Project	The Falls on Refugee Road	Addendum Number	3
Project Number	23446	Date	07/10/2025
To	All Bidders

This addendum contains changes to the requirements of the bidding Documents, Project Manual and Construction Drawings which have been issued to date. Such changes are to be incorporated into the Construction Documents and shall apply to the work in the same meaning and force as if they had been included in the original documents. Wherever this Addendum modifies a portion of a paragraph of the Project Manual or a portion of any Drawing, the remainder of the paragraph or Drawing shall remain in force.

PROGRESS DRAWING NOT FOR CONSTRUCTION	05/01/2025
	23446
	P101-A
	CD PROGRESS SET

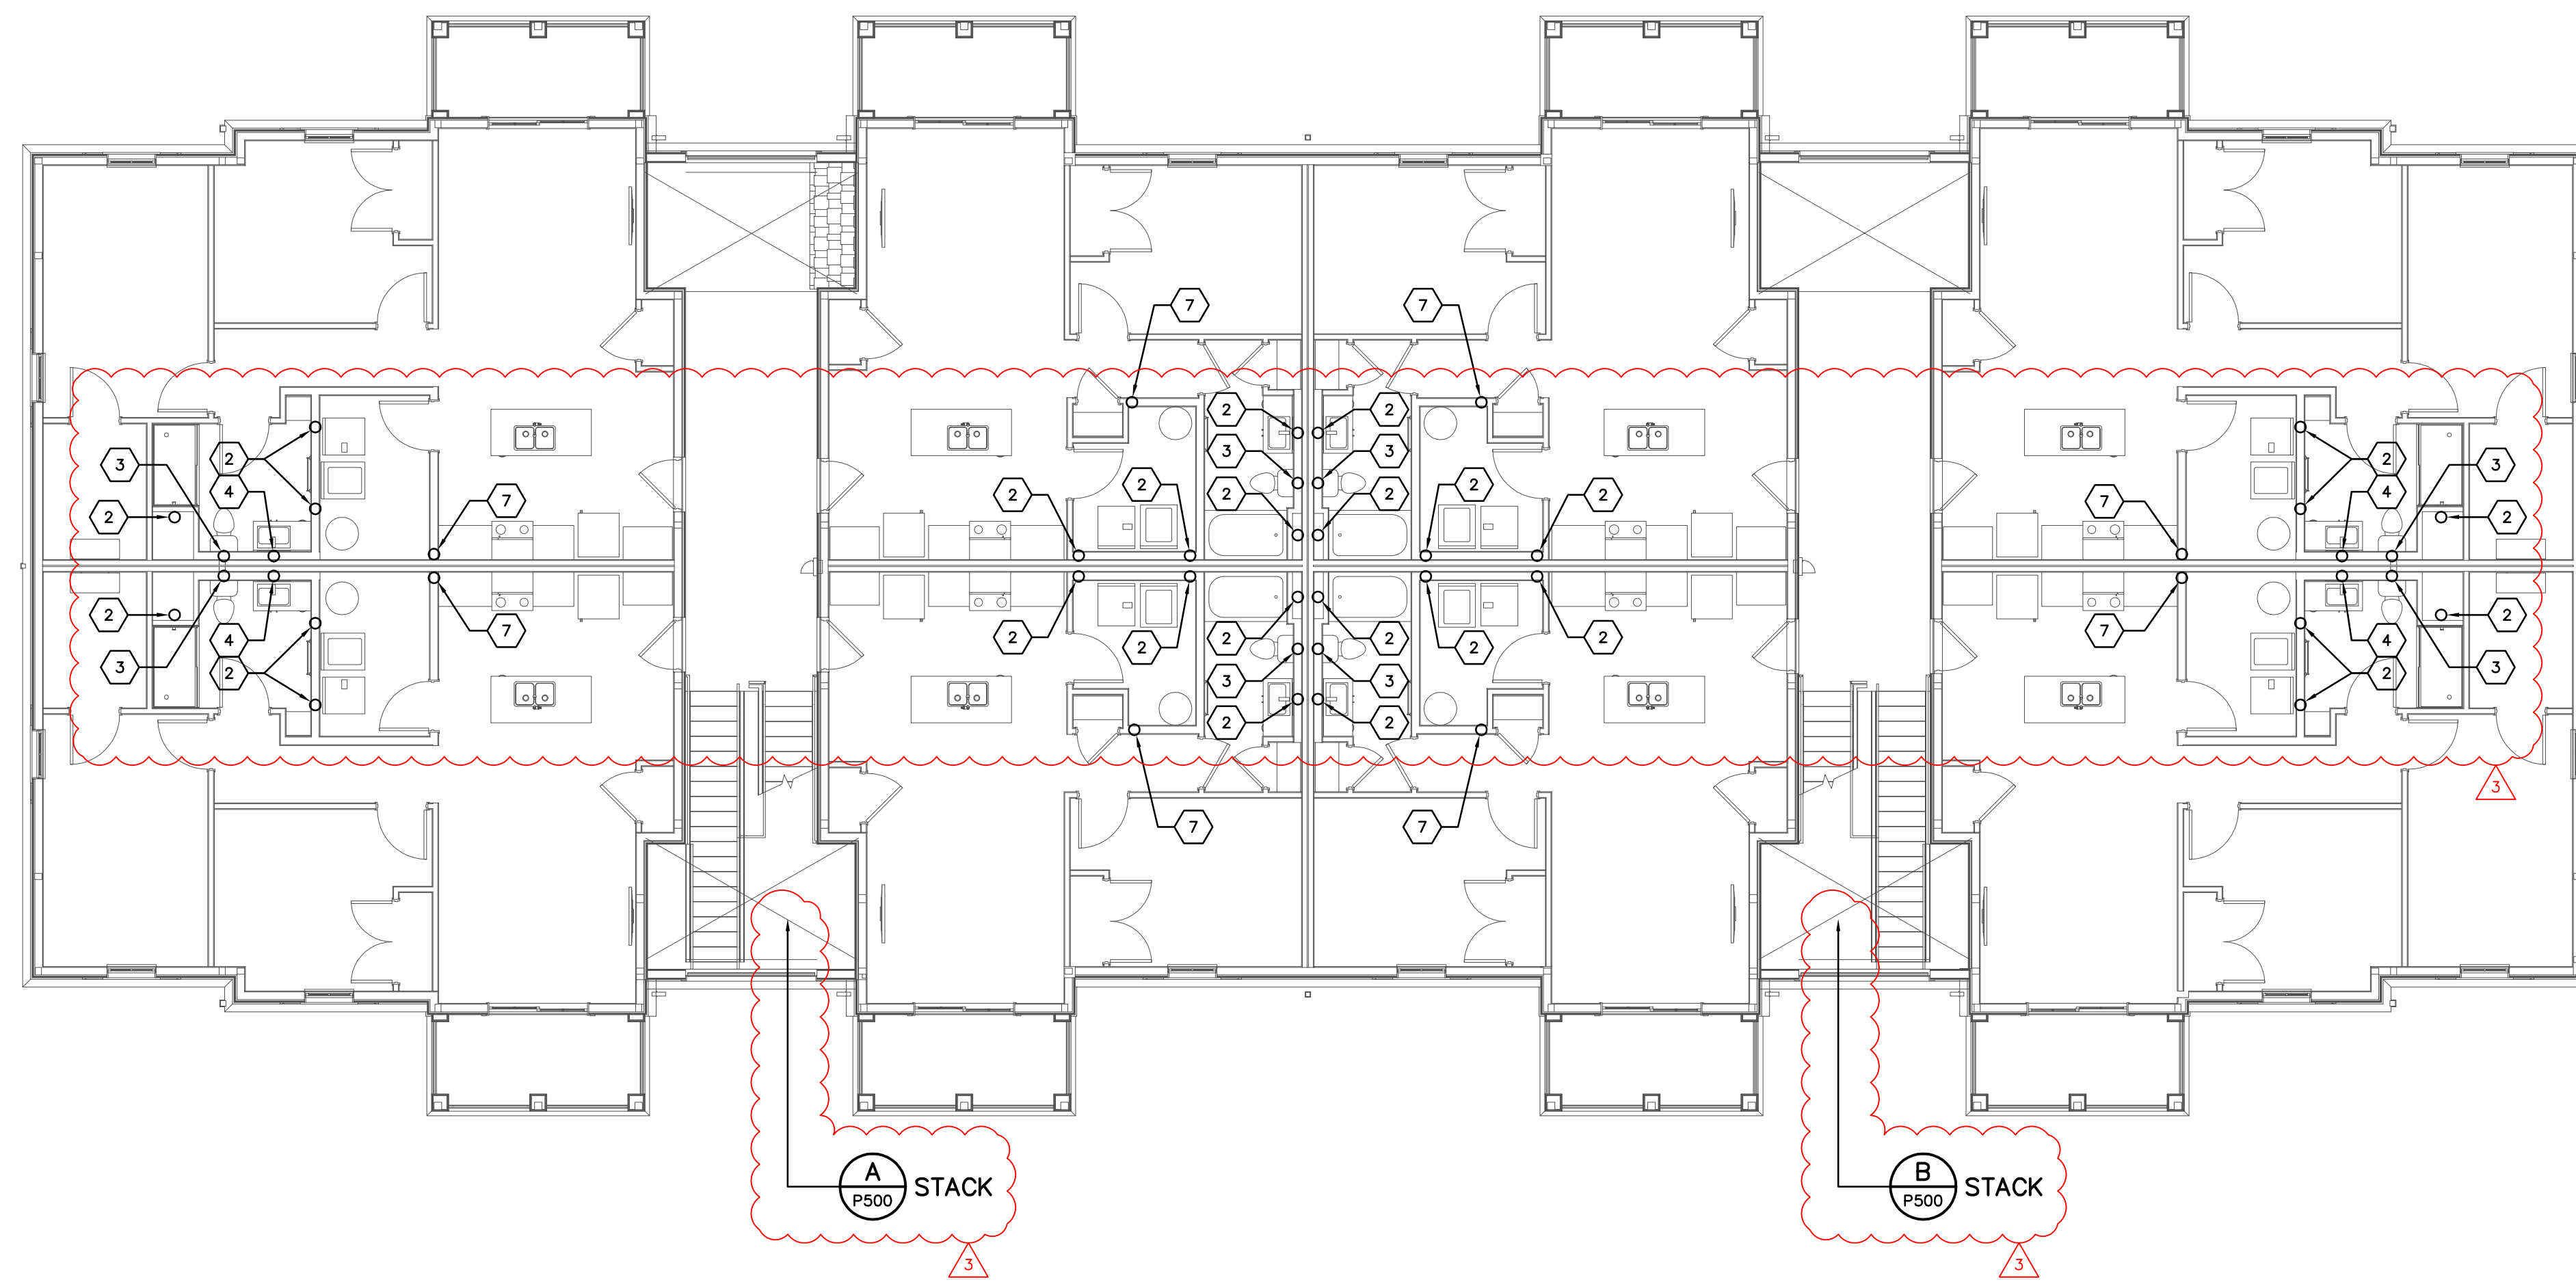
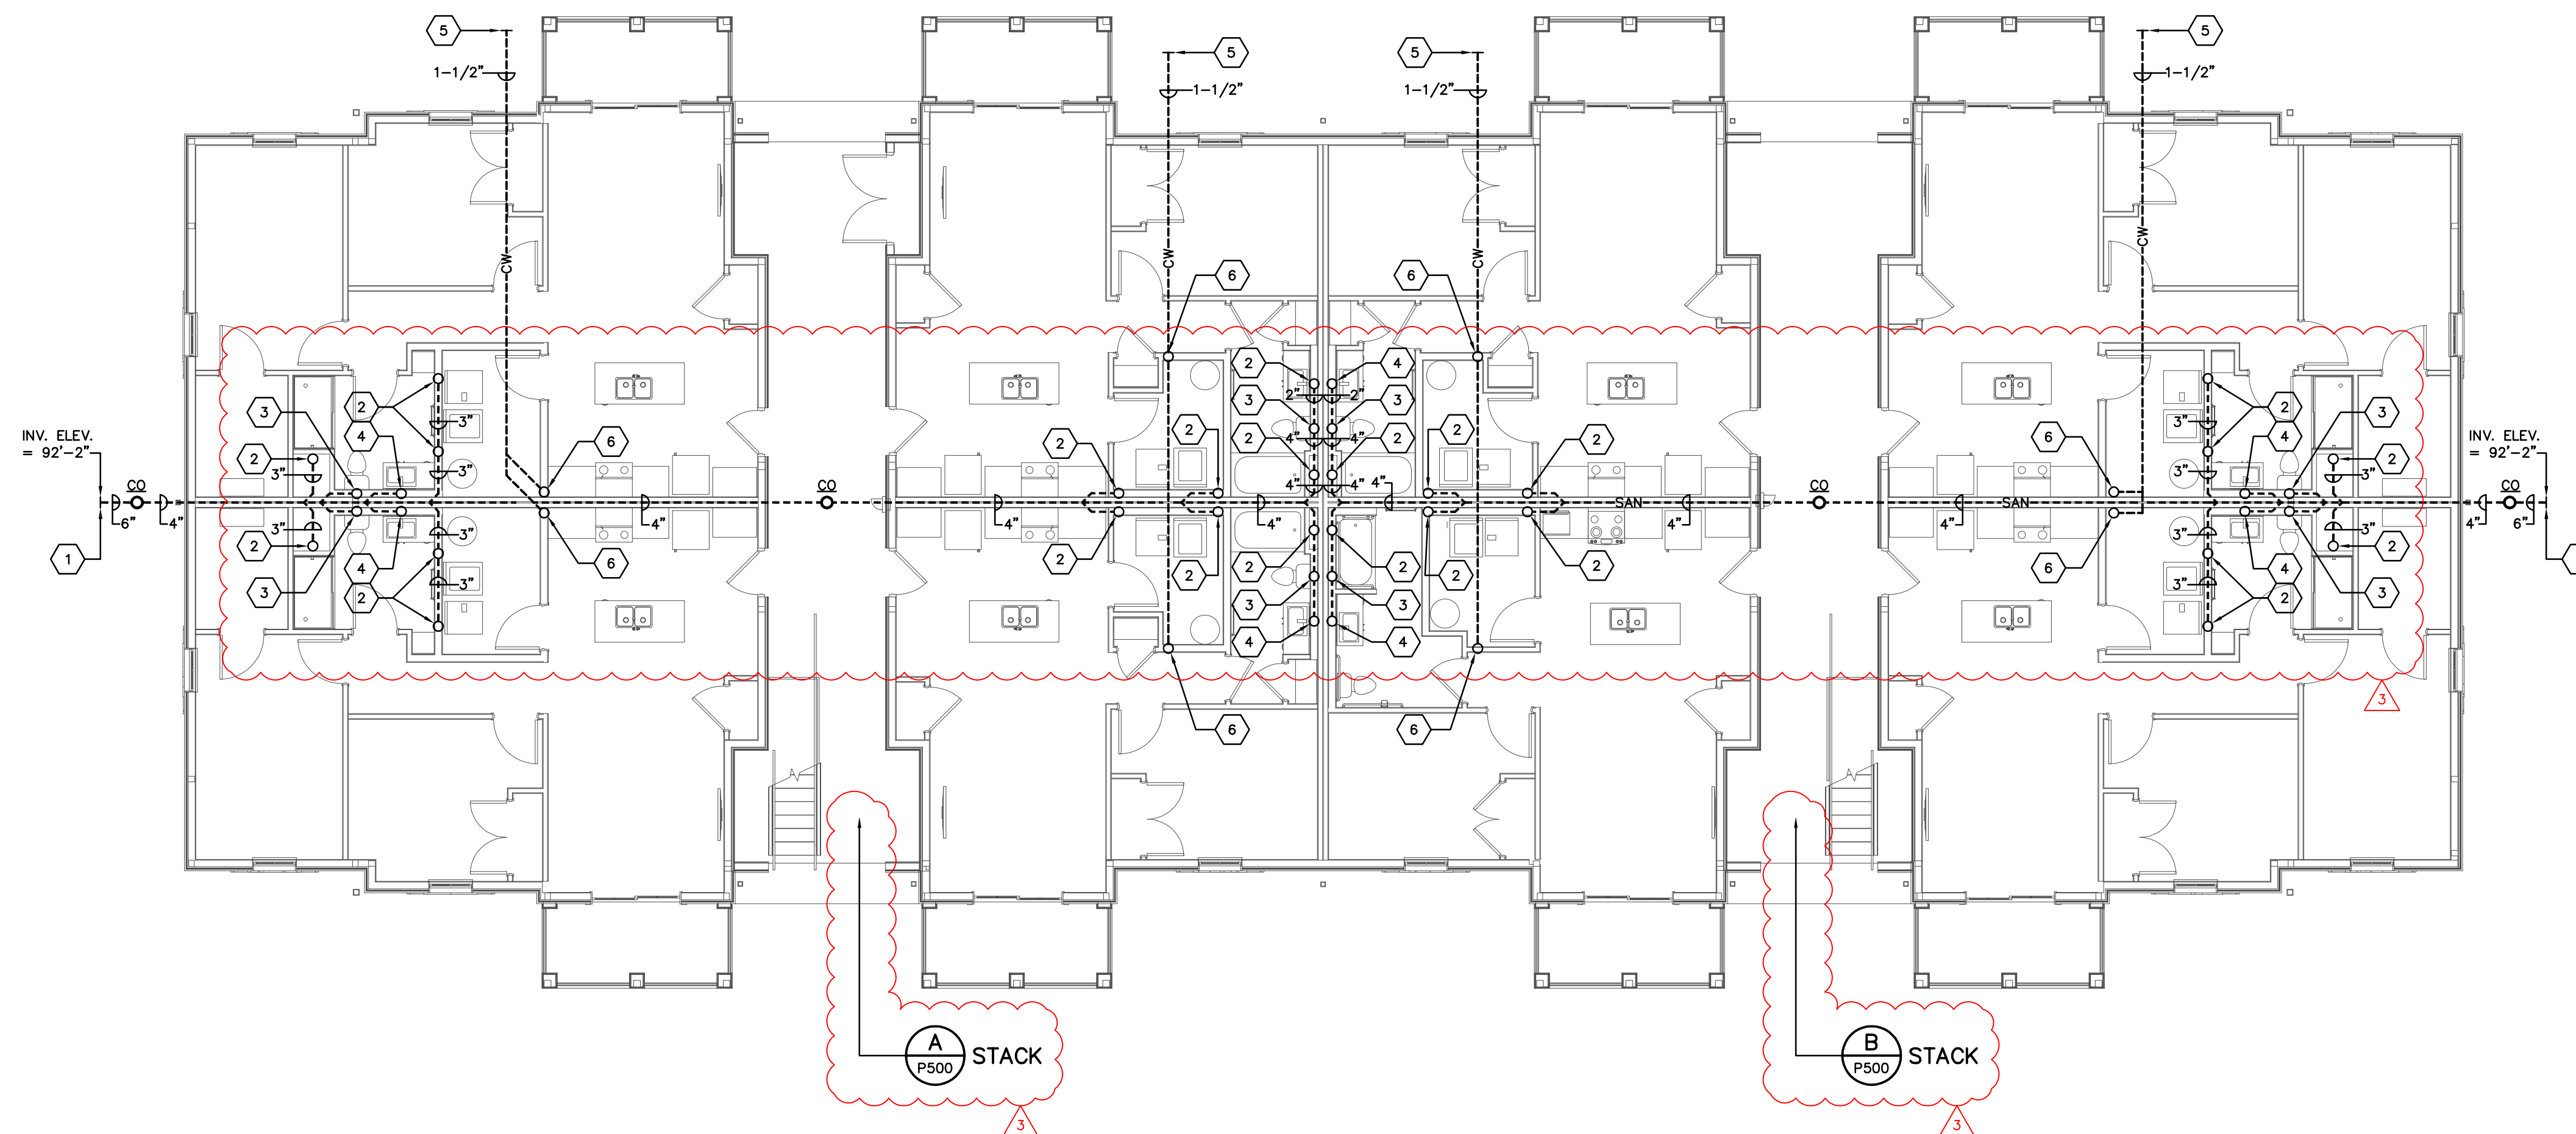
Sheet P101-A

1. Revised sanitary piping layout.
2. Revised Coded Notes 4, 6, & 7.
3. Added stack diagram designations.
